# H PRODUCT UPDATE

## TIREMAAX®

LIT NO: P56059

DATE: November 2020

**Standard Hoses**

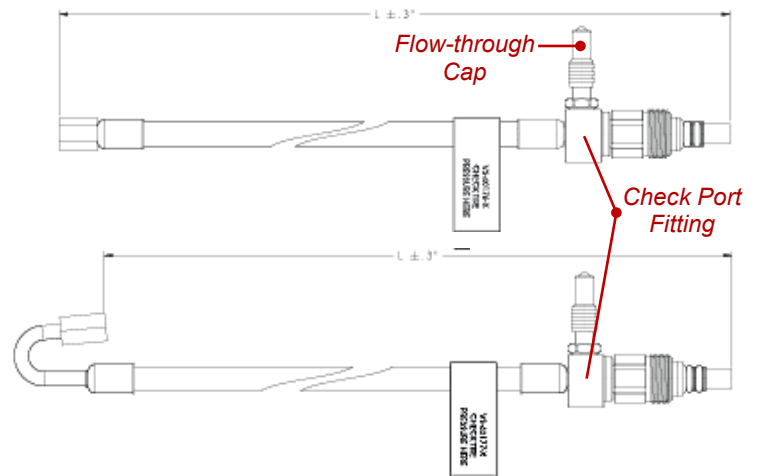
Hendrickson Trailer Commercial Vehicle Systems announces a new thermoplastic tire hose option for TIREMAAX®. The new tire hoses feature an integral check port fitting with flow-through cap that allows tire pressure to be checked at the port without removing the hose from the hubcap. The hoses are designed for use with 22.5", dual and super single tires. Notice that the yellow "Check Tire Pressure Here" label has been eliminated from the new hoses. The new integral check port tire hose option will be available beginning mid-December 2020.

New part numbers have also been established for customers buying tire hose kits in lieu of TIREMAAX kits, and for those with aftermarket tire hose requirements (see charts below). The new hoses are backwards compatible and may be used to replace current tire hoses in 22.5" tire applications. Refer to L878 Rev Q TIREMAAX Parts List for complete details.
